SITE ANALYSIS

TAB NO.4

MASTER PLAN NARRATIVE

URBAN DESIGN STANDARDS

COMMERICAL/RETAIL/OFFICE ENTRY

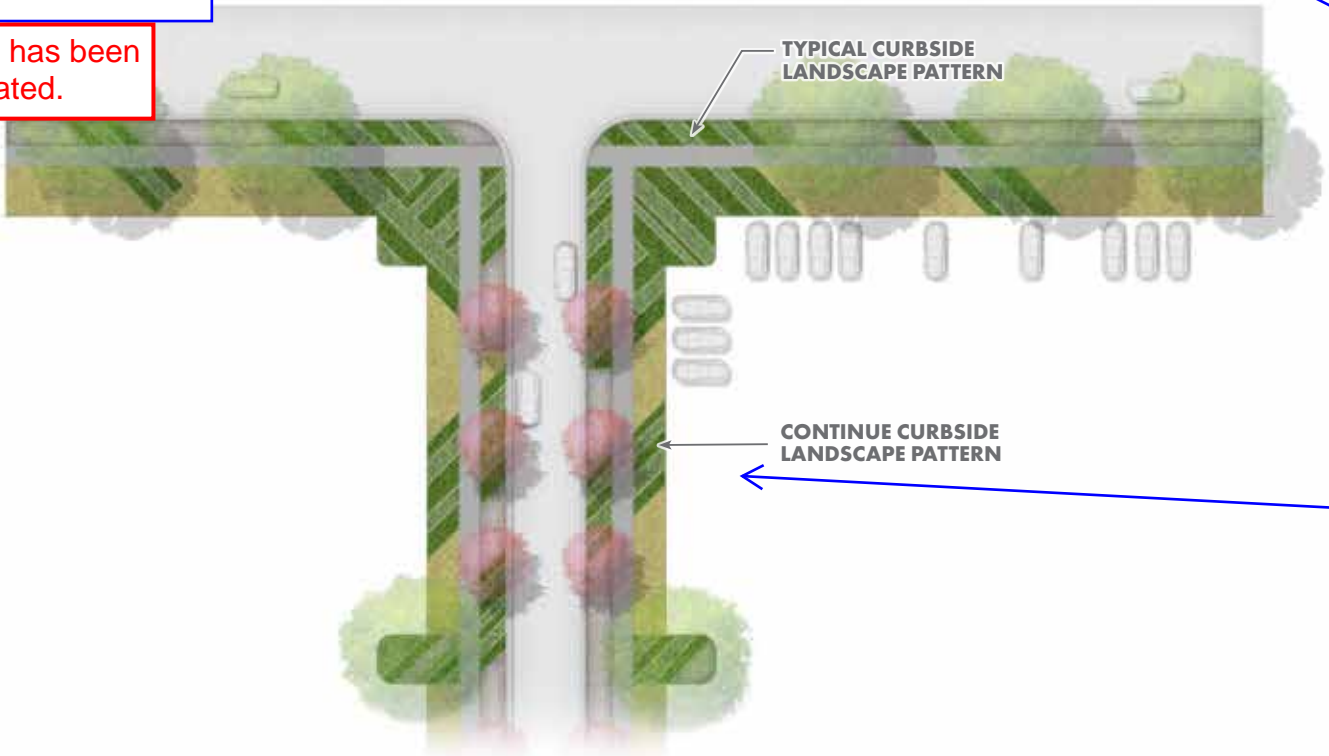
Allow for more hard
scape or plaza for
office/retail

This has been
updated.

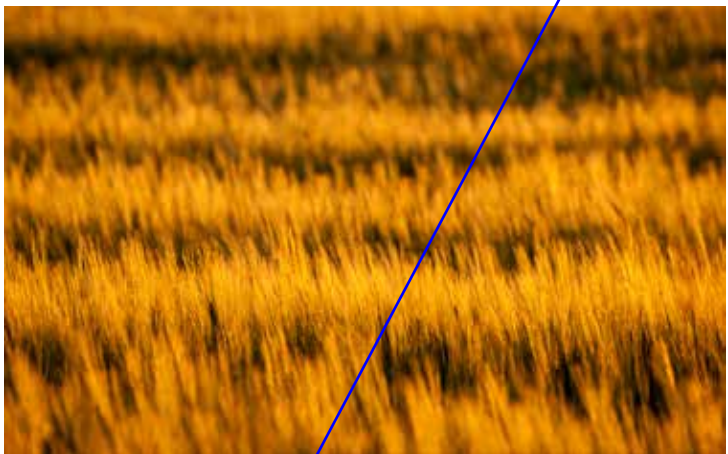
is this
meant to be
the same
for
commercial
vs
industrial?

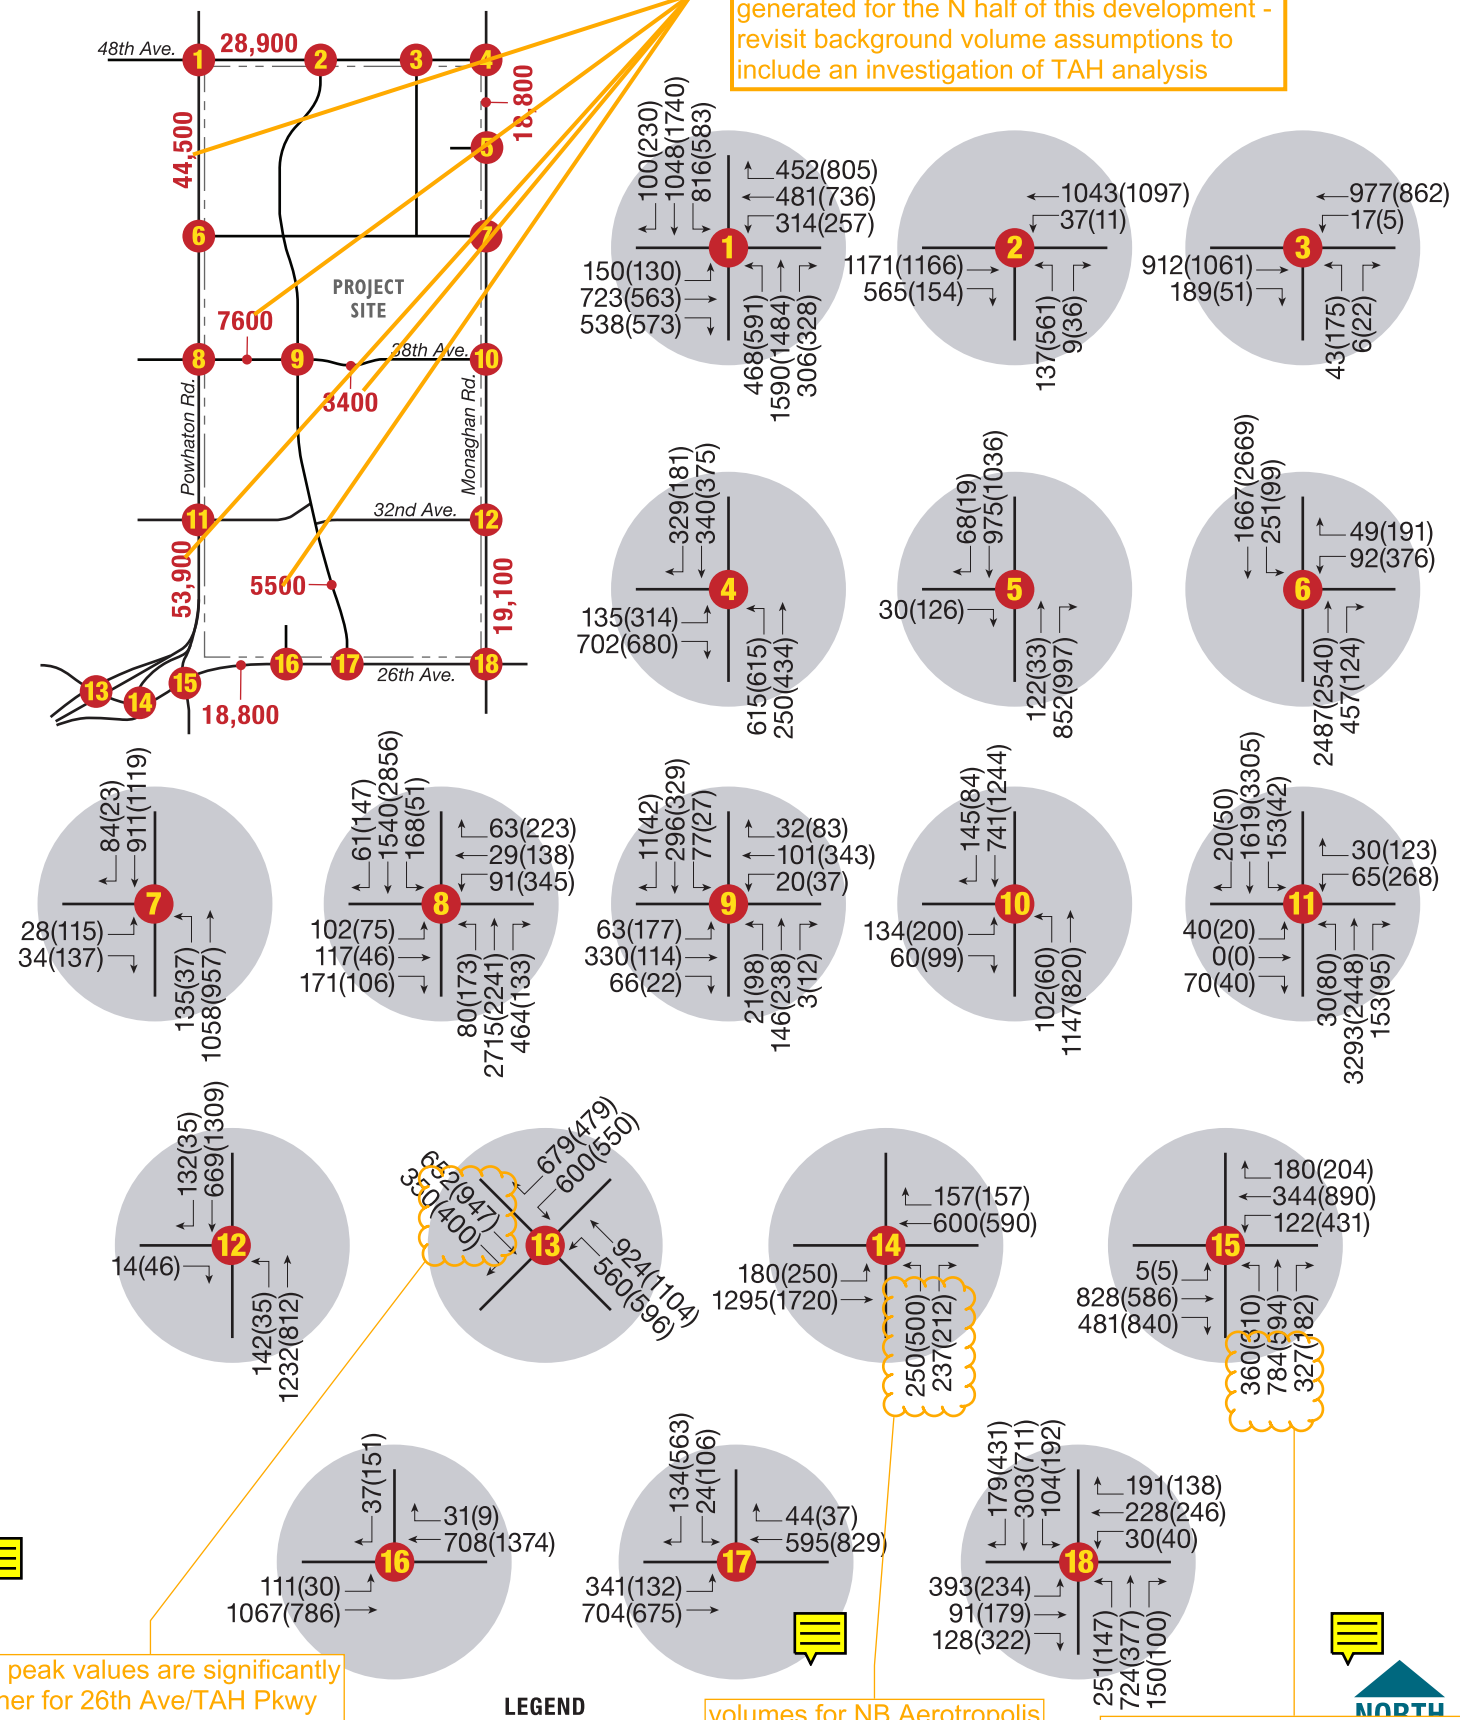
NEATS and AECOM both analyzed year 2040 - discuss how volumes were further projected to 2045 (ie was a growth rate used), or was it the updated DRCOG model as basis, etc
